Staff Report

Knoxville Historic Zoning Commission

File Number: 10-C-25-HZ

Location: 1334 Grainger Ave. **Parcel ID** 81 L G 007
District: Old North Knoxville H
Zoning: RN-2 (Single-Family Residential Neighborhood)
Description: Folk Victorian with Queen Anne Influence, c. 1885

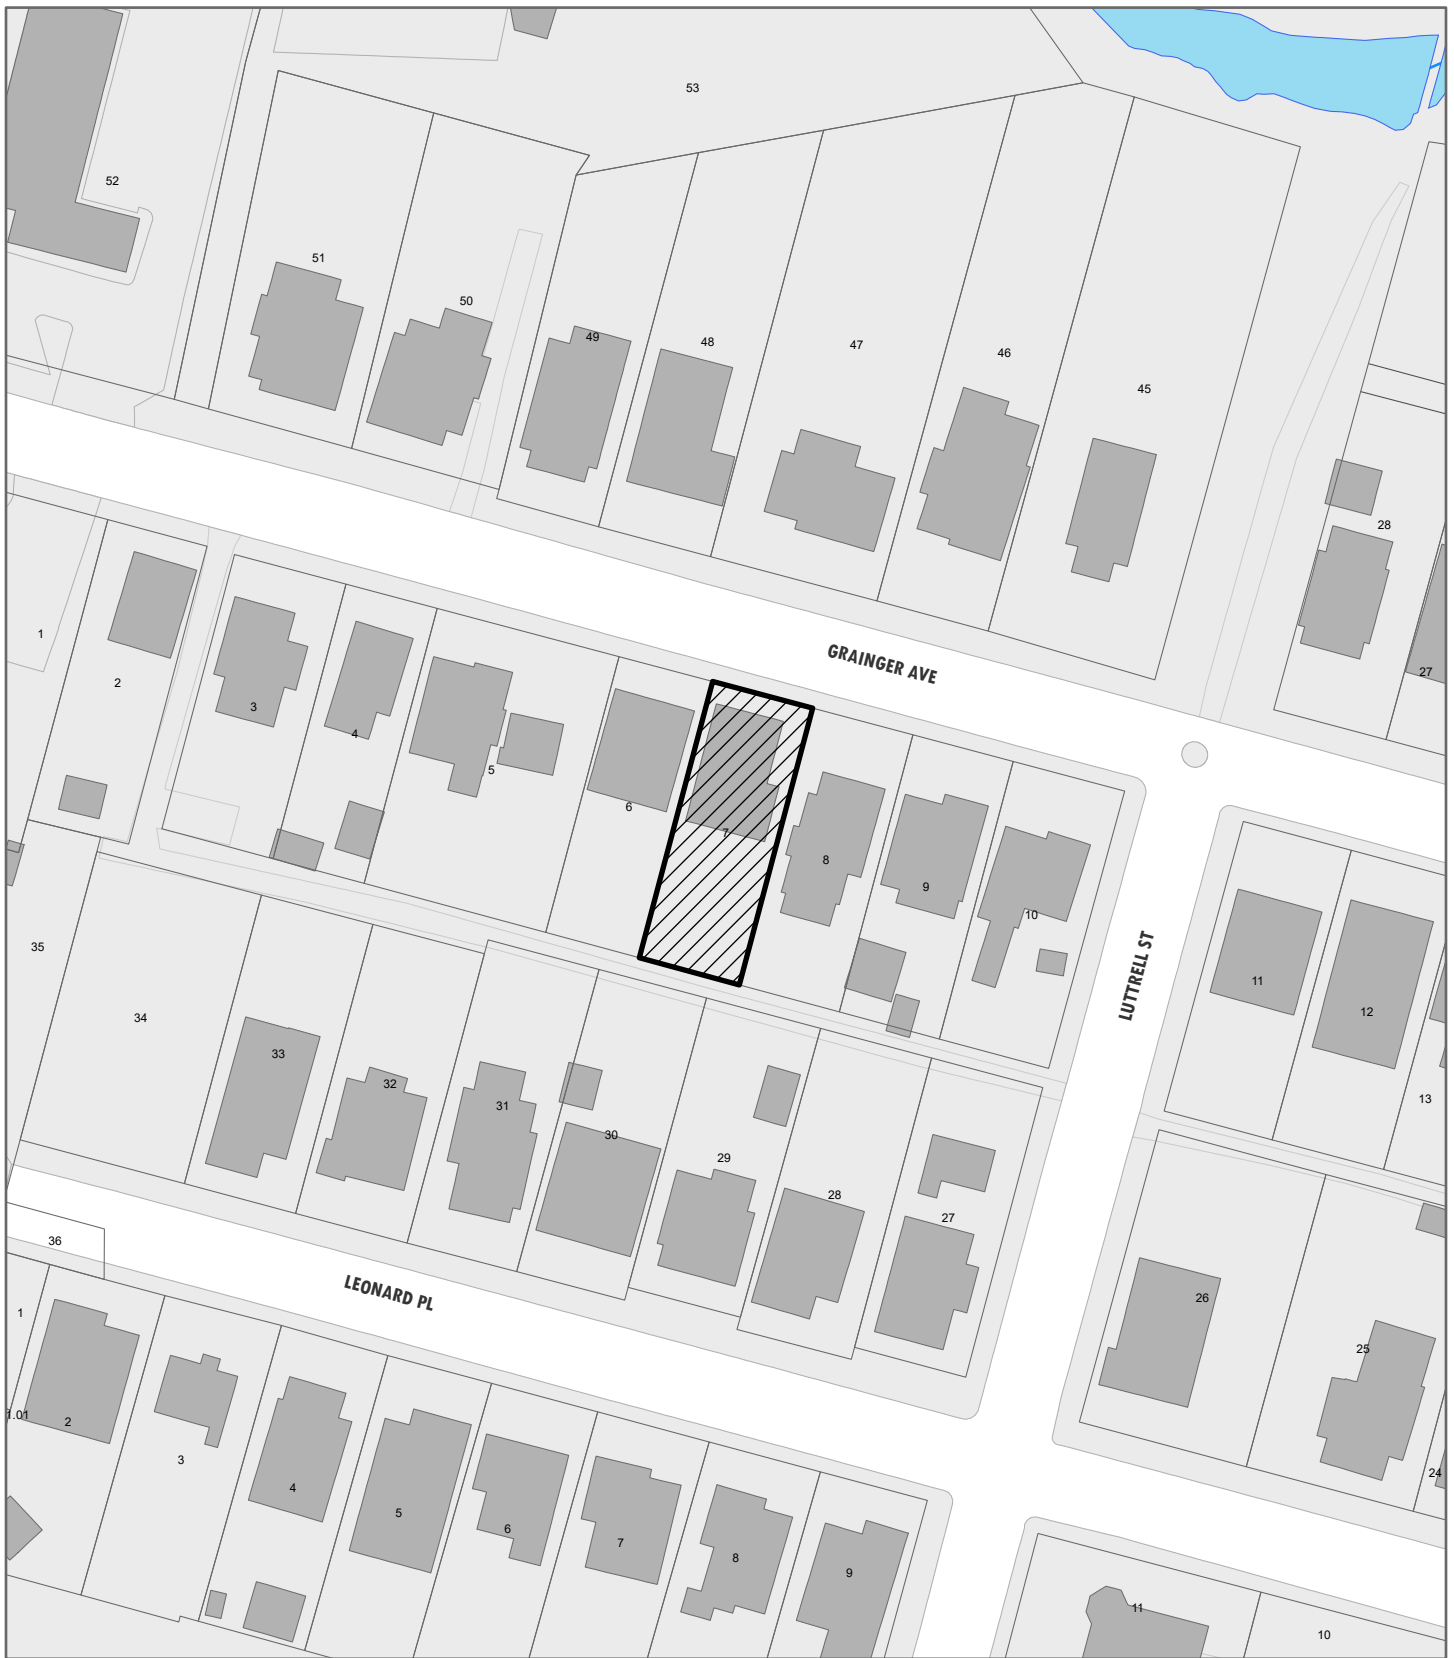
1. 1334 Grainger Avenue is a contributing resource to the Old North Knoxville overlay and the National Register-eligible Brownlow district.
2. The disassembly, reconstruction, and repairs to the brick foundation on the front porch and brick wing walls, in accordance with Preservation Brief 2, were approved administratively on 9/16/2025, along with the in-kind replacement and repair of deteriorated porch elements including flooring, ceiling, skirt boards, trim, box beam, soffit, and wooden handrailing. The replacement of the character-defining front porch columns, which might be original, requires review by the Historic Zoning Commission.

3. The applicant stated that the porch columns and capitals are likely made of deteriorated wood composite material with a faux grain and composite capitals, indicating that they are not original to the house. Survey records and historic photographs of the property indicate that the existing Ionic columns are original to the building or at least closely replicate the originals. Regardless of whether or not they are original, the front porch columns are character-defining features that the design guidelines recommend should be replicated if they are too deteriorated to repair.

4. The front porch columns and capitals are in poor condition and have experienced decay from moisture damage that renders them unsalvageable, so replacement is appropriate. The proposed 8" round, wooden, smooth-finished, tapered, and painted replacement columns are a close match to the existing columns, and the new cementitious capitals are an exact replica of the current Scamozzi-variant Ionic capitals. The replacement columns and capitals are appropriate, but should rest on a square plinth with the same profile to match the existing, instead of a circular one. The applicant should verify that the replacement columns and capitals match the diameter and width of the existing.

Staff recommends approval of Certificate 10-C-25-HZ, subject to one condition: 1) the columns rest on a square plinth with the same profile as the existing and to have the same diameter, and the capitals to have the same width as the existing.

20250909_123734.jpg; 20250909_123728.jpg; 20250909_123637.jpg; 20250909_123624.jpg;

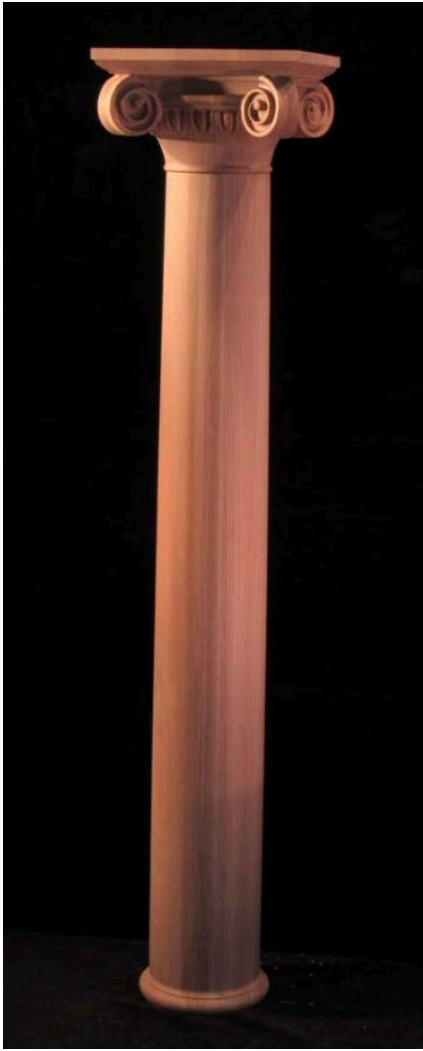
For the porch columns, what will the "period-appropriate" design be? We require detail drawings or product specifications when character-defining front porch columns are replaced. Our records of historic photos and surveys indicate that the columns are probably original, so please provide some more pictures of the columns. The porch column replacement is the only scope of work that requires review by the HZC instead of staff. **I attached some tighter photos of the columns that are there now. It seems to me that they're made of a material that feels and looks like LP Smart Siding. It has a faux grain on it. I am planning to buy an 8", smooth, tapered, wooden column and planning to paint it . Like this:**

I would also like to replace the Schamozzi Capitals because the ones that are there now are in really bad shape (see pics attached) . I can get one that is an exact replica. It we be cementitious. Will look like this:

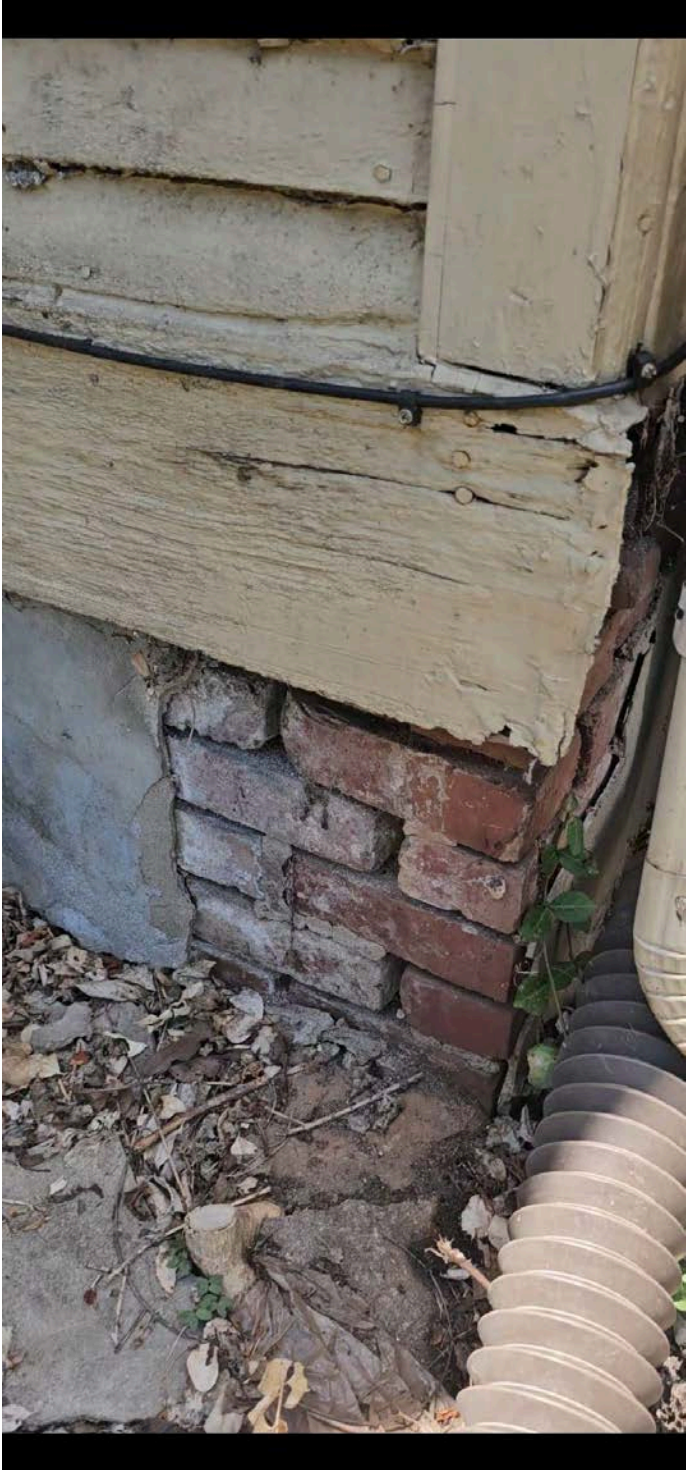
Foundation:

Front Left Corner:

Support wall of house and unstack existing brick down to below grade where mortar has turned to powder making bricks are stable.

Replace rotten mud sill at front left corner of house.

Front Porch

Re-build brick wall of porch foundation on all three sides by supporting the roof and porch floor, disassembling bricks one by one (mortar has turned to powder) setting aside, cleaning, and re-using brick. Also, dig out and install concrete footings to support front porch foundation wall before re-laying bring back in place.

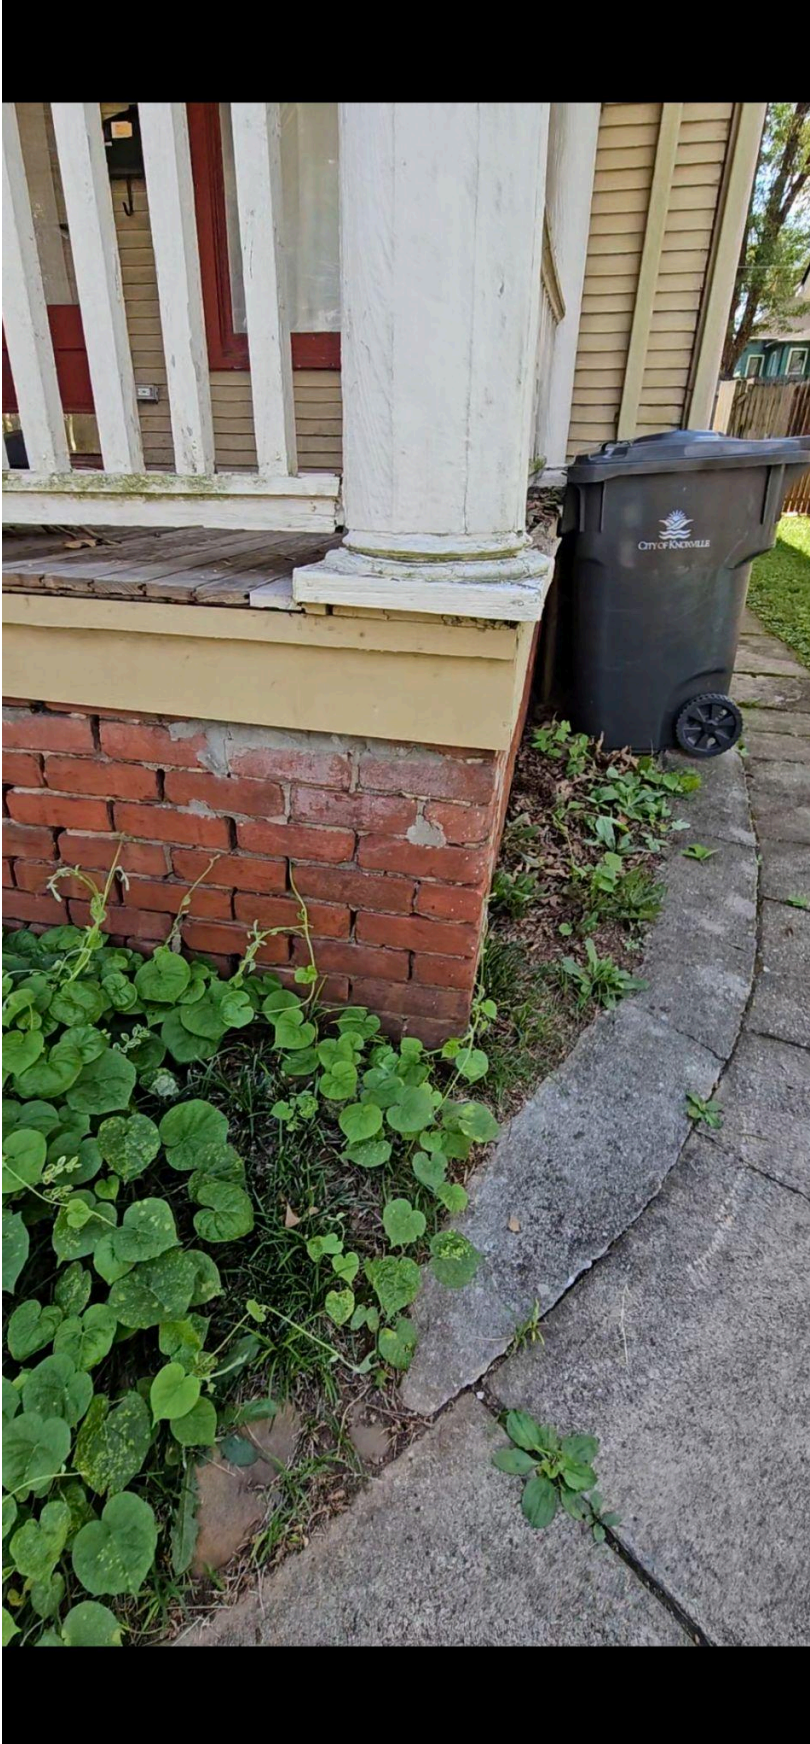
Remove concrete caps over left and right masonry "wing" walls at sides of concrete stair and set aside, then disassemble brick wing walls, dig and pour footing, and then rebuild wing walls, and re-set existing concrete caps.

Remove all old, rotten, T&G porch flooring and discard, along with all skirt boards and trim. Replace T&G flooring with new.

Remove existing (non-original), composite support columns and discard. Replace with period-appropriate, wooden columns.

Remove dilapidated handrail and replace with new handrail, identical to what is there now.

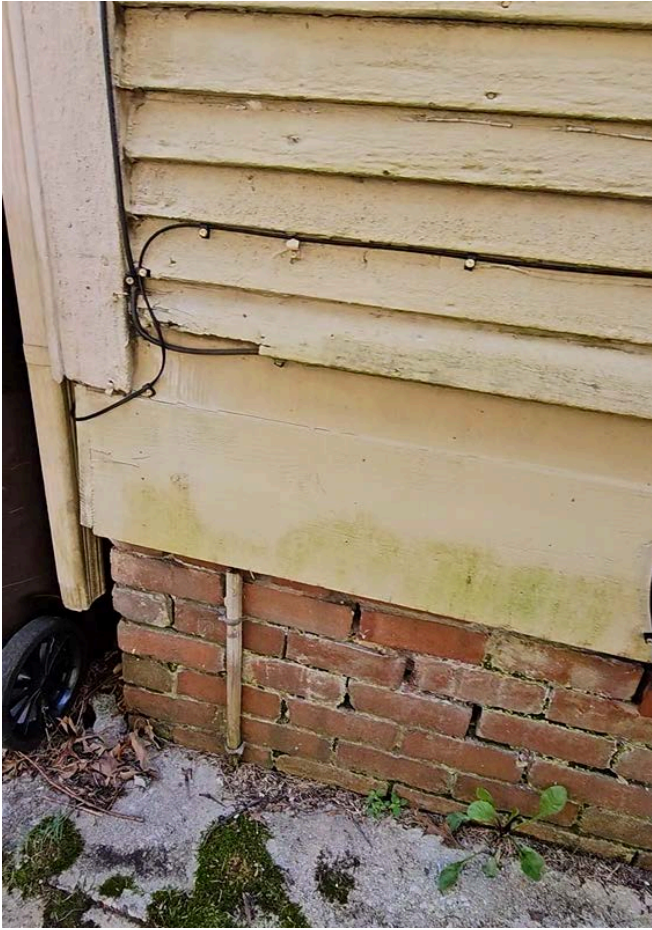
Repair and tuck point deteriorated portions of foundation at right front corner and along right side all the way to back right porch.

Repair rotten portions of TnG porch ceiling, as well as rotten or missing portions of box beam and soffit.
